1. Planning Board Meeting Materials 2026-01-05

AGENDA
York Planning Board Meeting
January 5, 2026
7:00 PM
York Public Library

TO: The York Planning Board
FROM: Brendan J. H. Summerville, Town Planner
DATE: 5 January 2026
RE: Sketch Plan Application Review – 60 Main Street
Map/Lot 0020-0001-A

TO: Planning Board
FROM: Brendan J. H. Summerville, Town Planner
DATE: 5 January 2026
RE: Sketch Plan Application Review – 985 & 995 US Route 1
Map 94 Lot 75A and Map 30A Lots 18 & 29

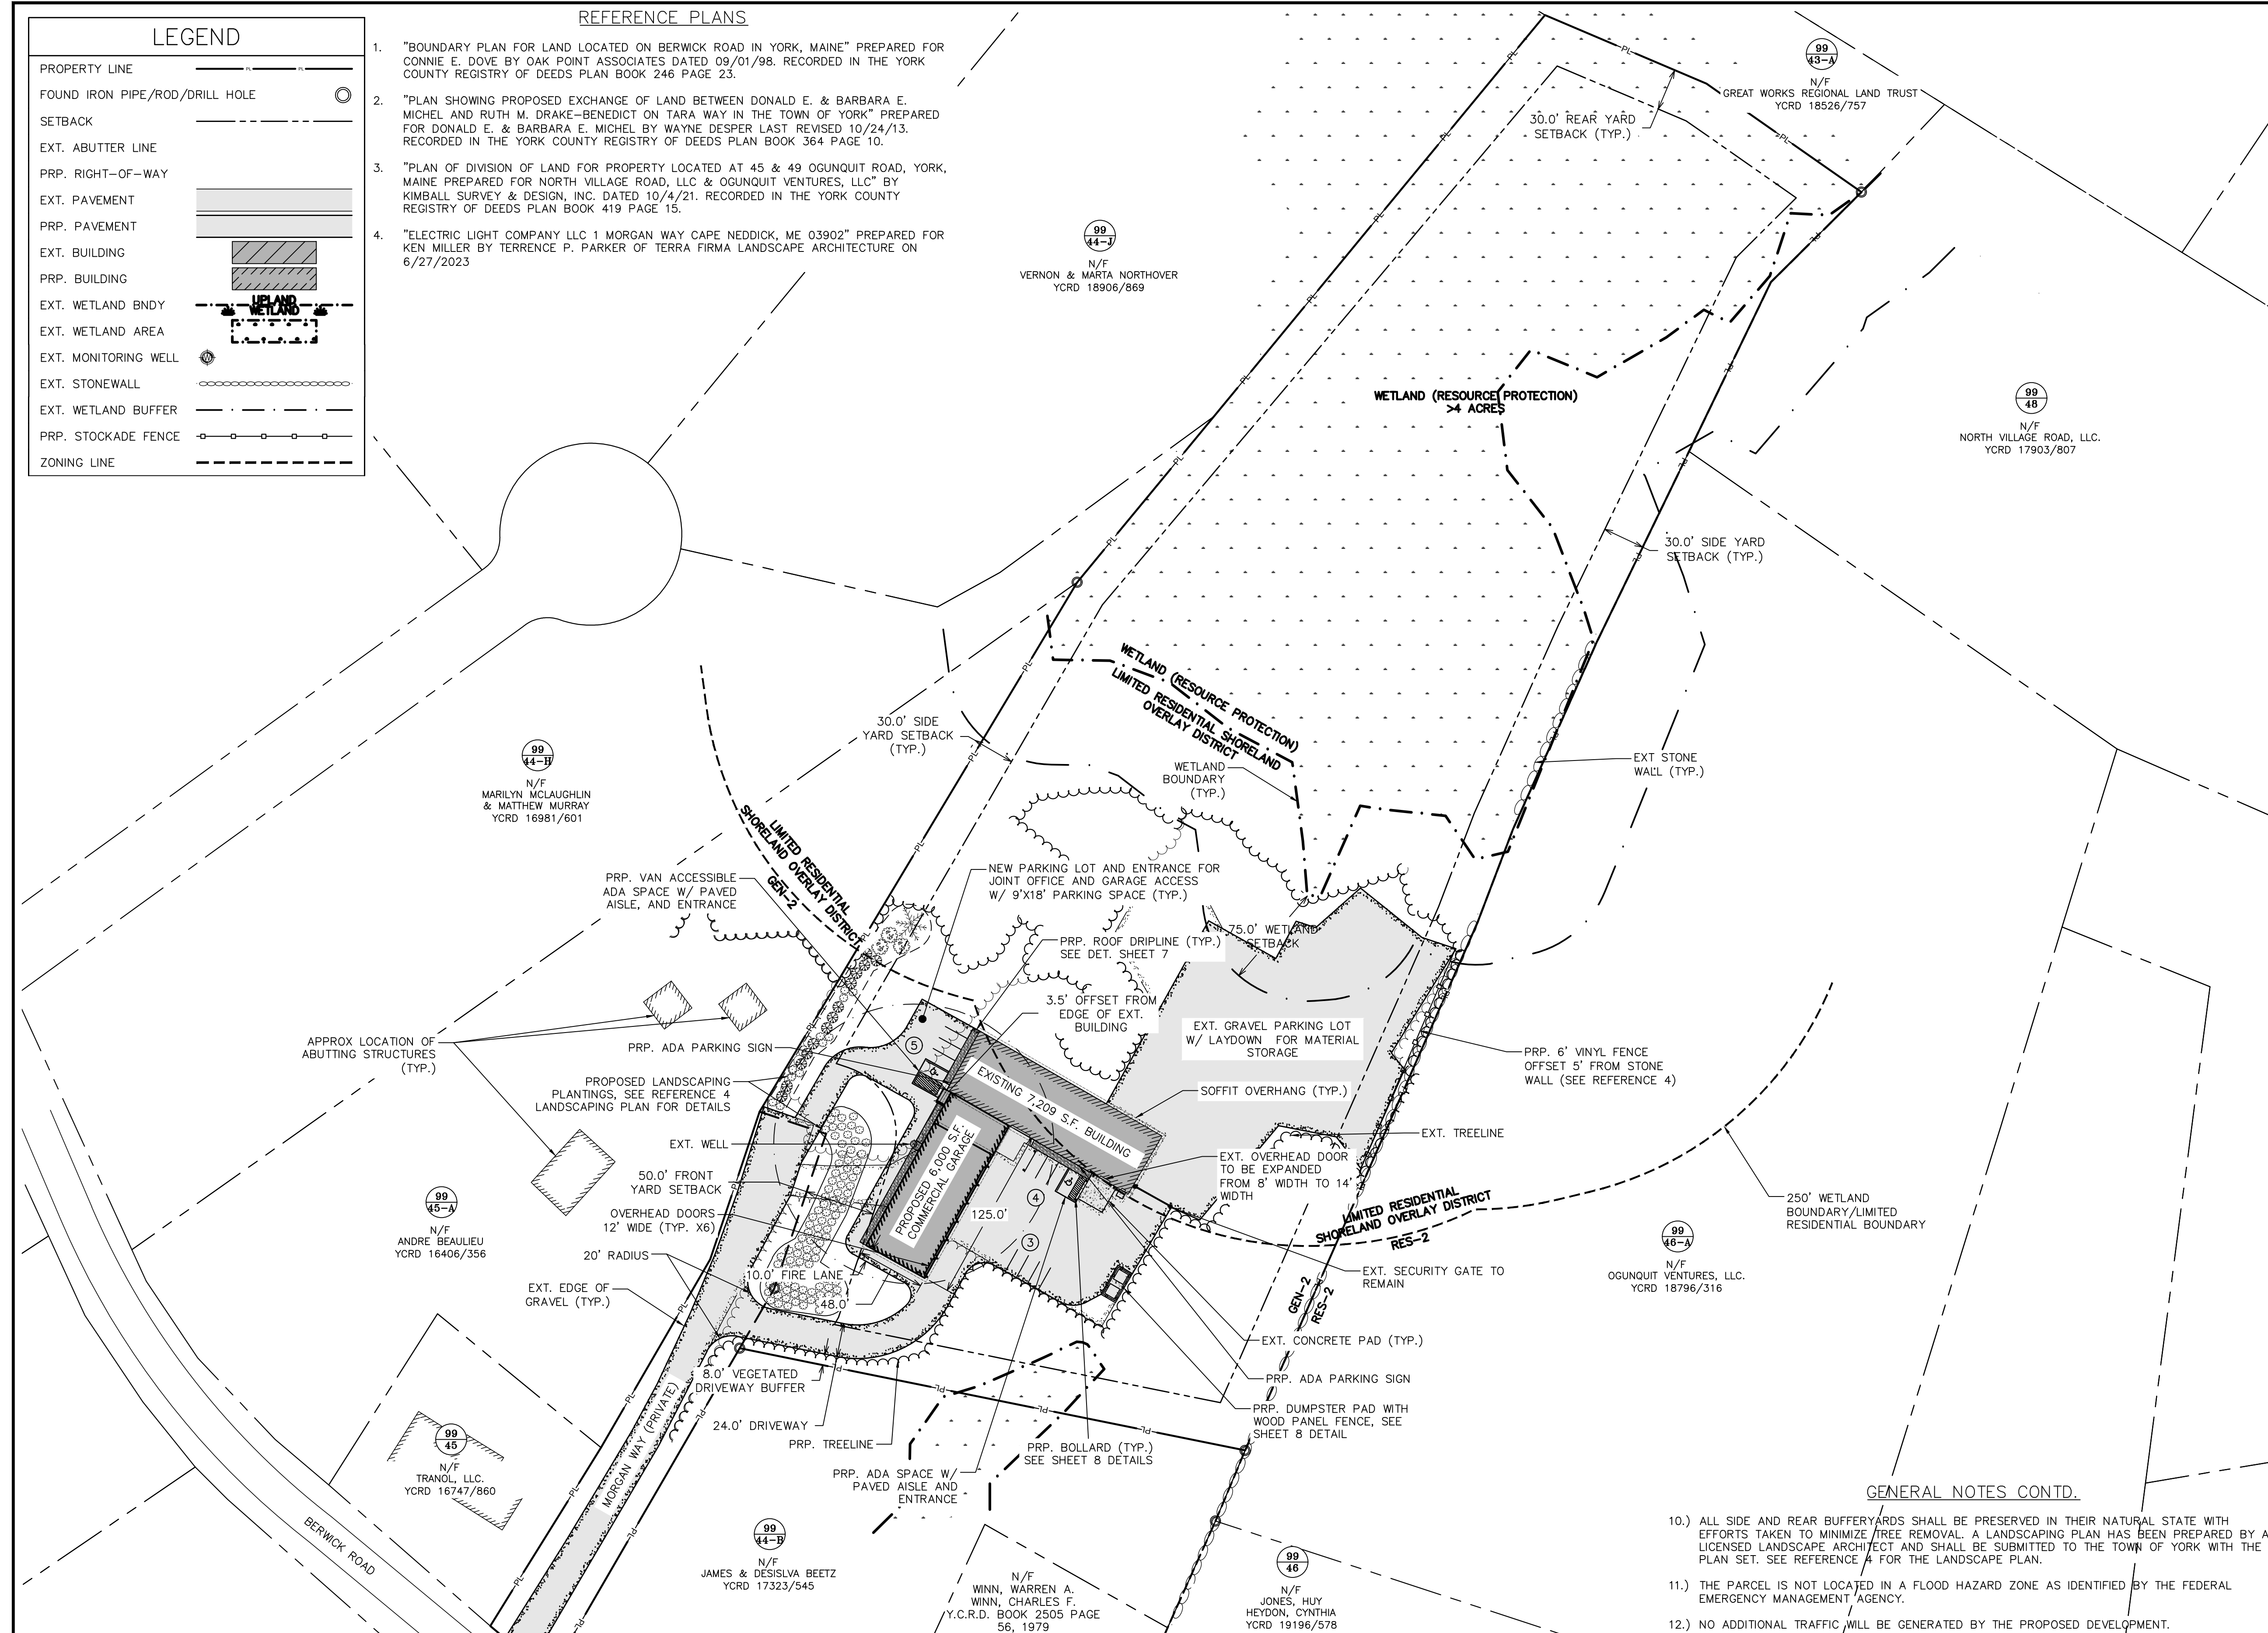
- b. In the GEN-2 zone there is a requirement not to exceed 25% impervious surface ratio for the lot. [and 20% for the area within the Shoreland Overlay Zone subdistrict Limited Residential per Article 8]. The plans (Sheet 2, Site Plan) appear to only include the buildings in the coverage calculations. See the Definitions section of the Zoning Ordinance for more information on calculating 'Impervious Surface Ratio'. The applicant has revised the plan, however, the calculations, (Plan Note 5 on sheet 2) reflect only gravel area for coverage (under 'PRP. SHORELAND..') and the note below states 'no additional impervious area' in the shoreland zone. The plans reflect approximately half the existing building within the shoreland zone, but the area doesn't appear to be reflected in the shoreland calculations. The riprap associated with the stormwater pond should be reflected in the total coverage amounts. The Applicant should confirm and revise accordingly.

- b. In the GEN-2 zone there is a requirement not to exceed 25% impervious surface ratio for the lot. [and 20% for the area within the Shoreland Overlay Zone subdistrict Limited Residential per Article 8]. The plans (Sheet 2, Site Plan) appear to only include the buildings in the coverage calculations. See the Definitions section of the Zoning Ordinance for more information on calculating 'Impervious Surface Ratio'. The applicant has revised the plan, however, the calculations, (Plan Note 5 on sheet 2) reflect only gravel area for coverage (under 'PRP. SHORELAND..') and the note below states 'no additional impervious area' in the shoreland zone. The plans reflect approximately half the existing building within the shoreland zone, but the area doesn't appear to be reflected in the shoreland calculations. The riprap associated with the stormwater pond should be reflected in the total coverage amounts. The Applicant should confirm and revise accordingly. This has not been addressed. The plans reflect no changes.

GRADING & UTILITY PLAN
ELECTRIC LIGHT COMPANY, INC.
1 MORGAN WAY, CAPE NEDDICK, ME

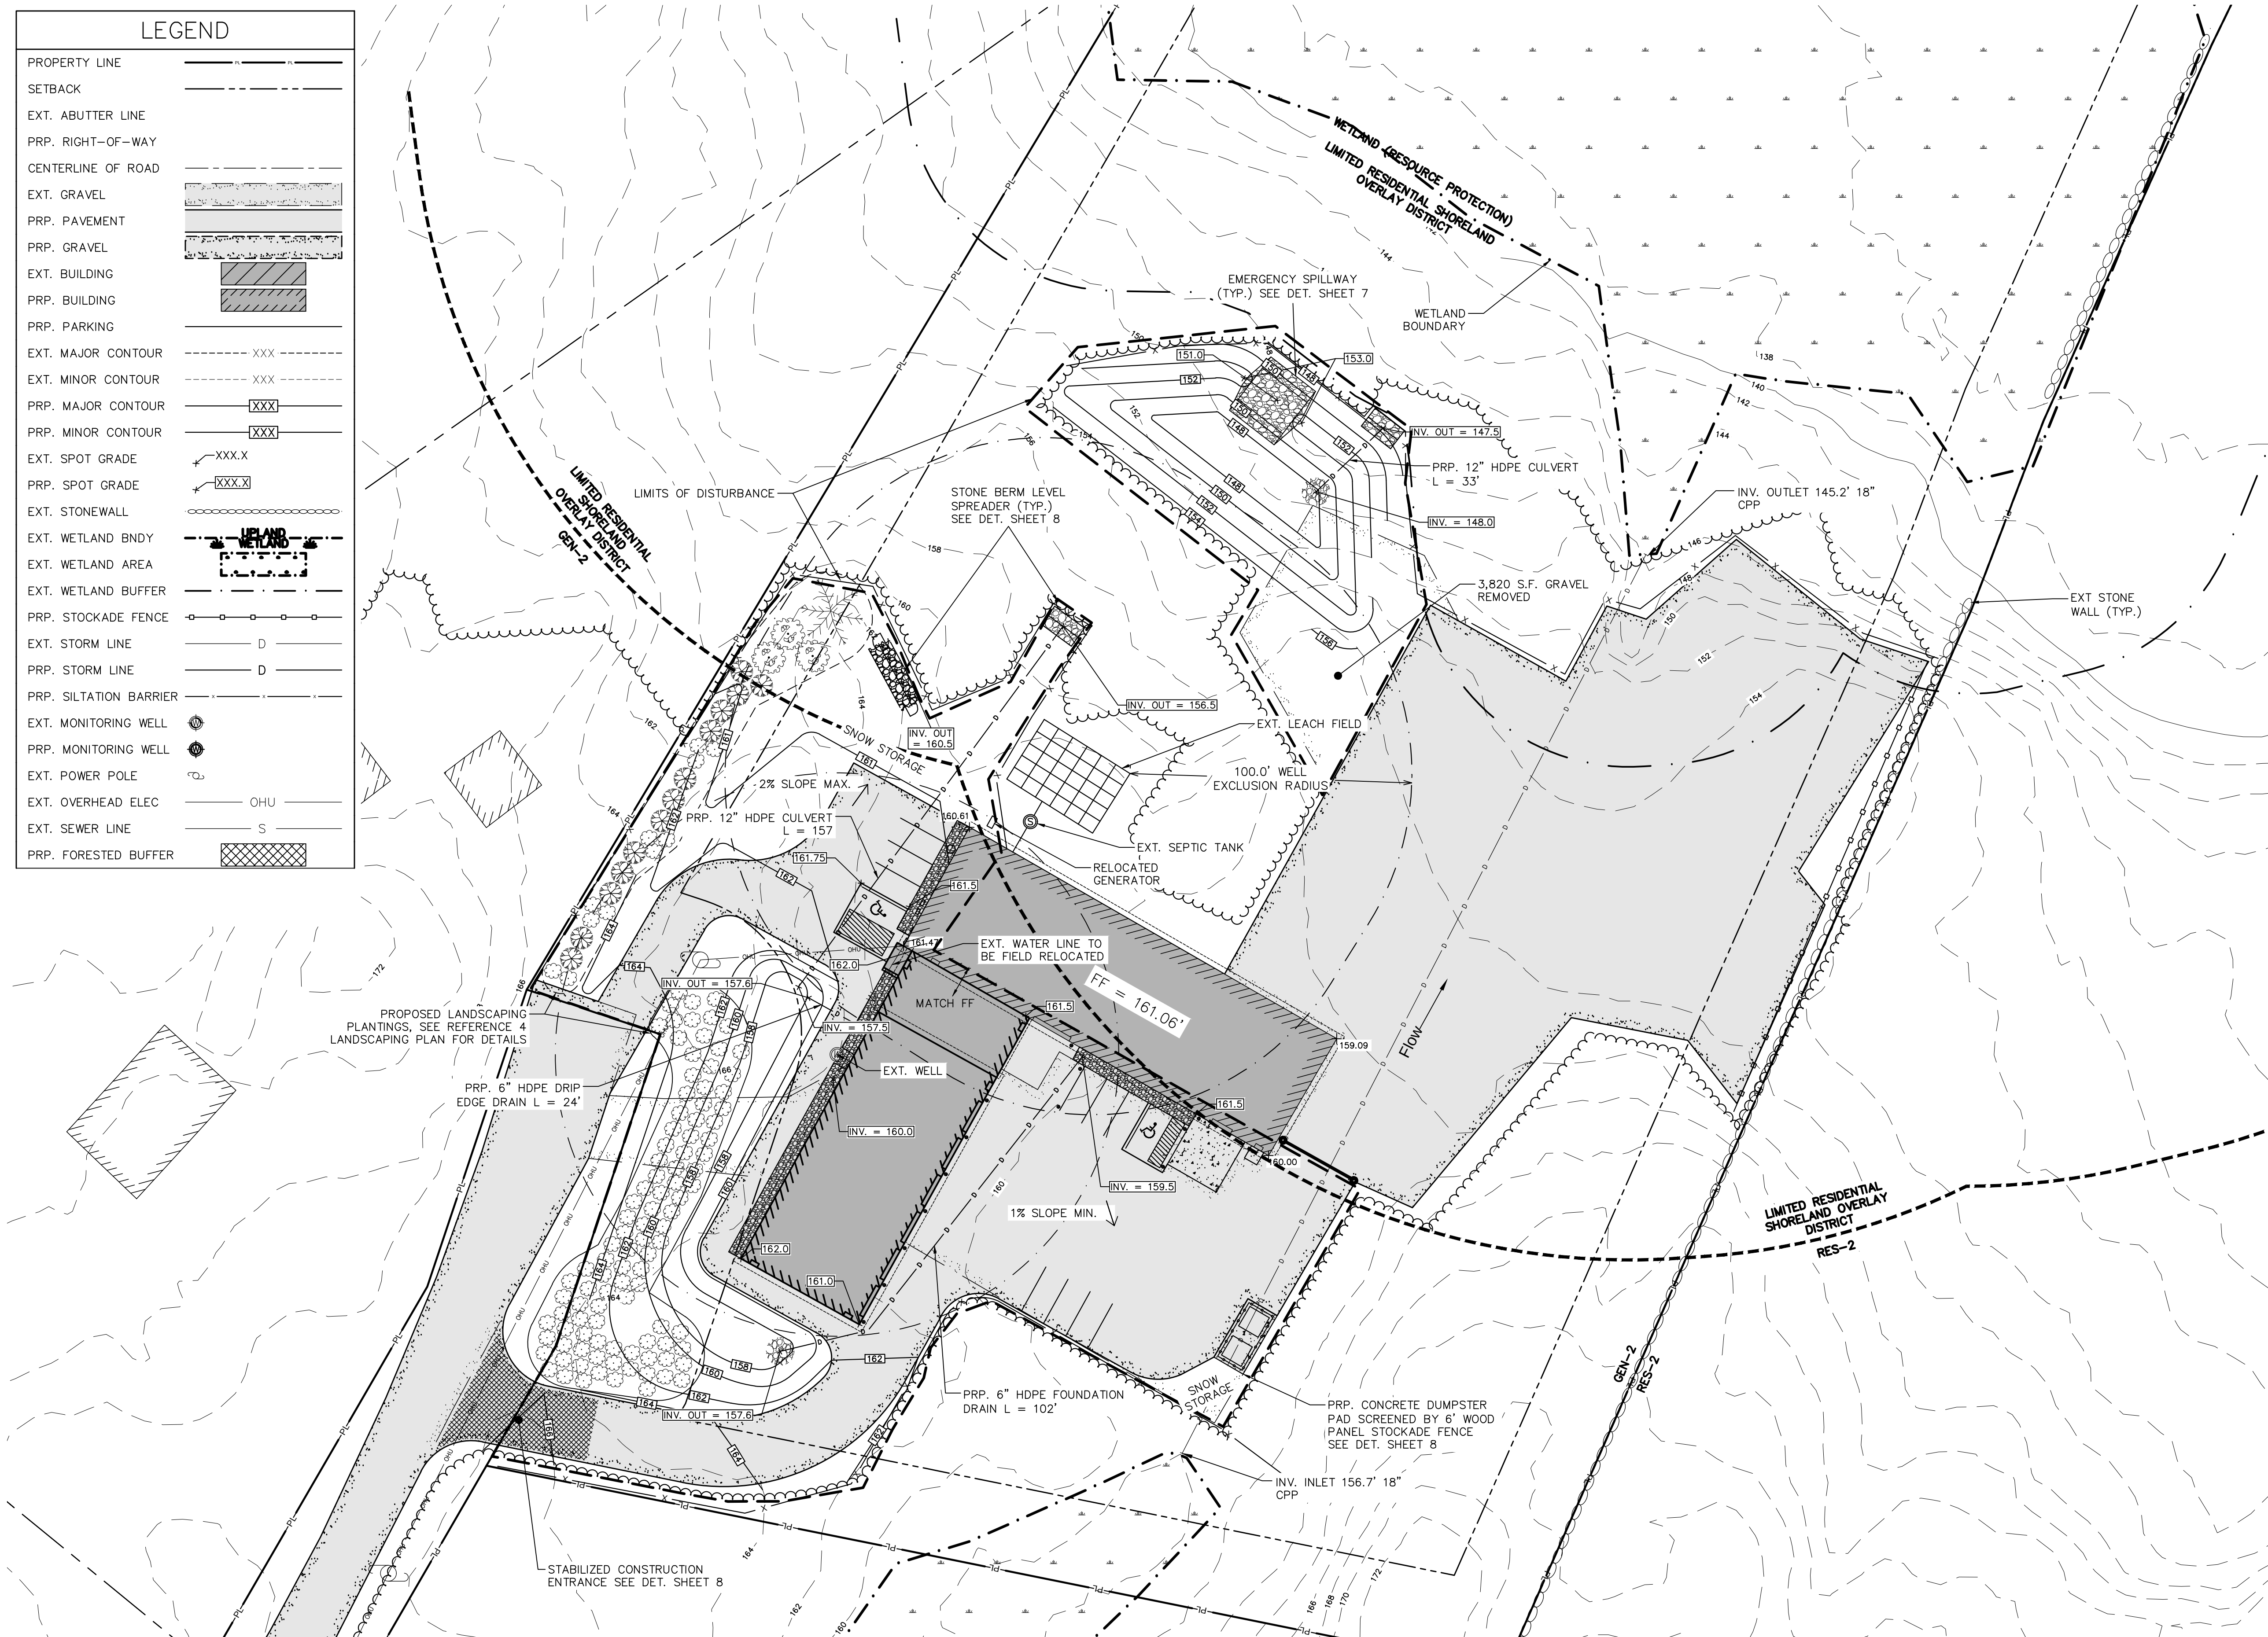
E	ADDED LEVEL SPREADER TO SWALE AS PER GP	11/26/25
D	PLANNING BOARD REVS	10/23/25
C	PLANNING BOARD REVS	9/5/25
B	PLANNING BOARD REVS	1/6/25
A	TOWN PLANNER REVS	7/24/24
NO.	DESCRIPTION	DATE
	REVISIONS
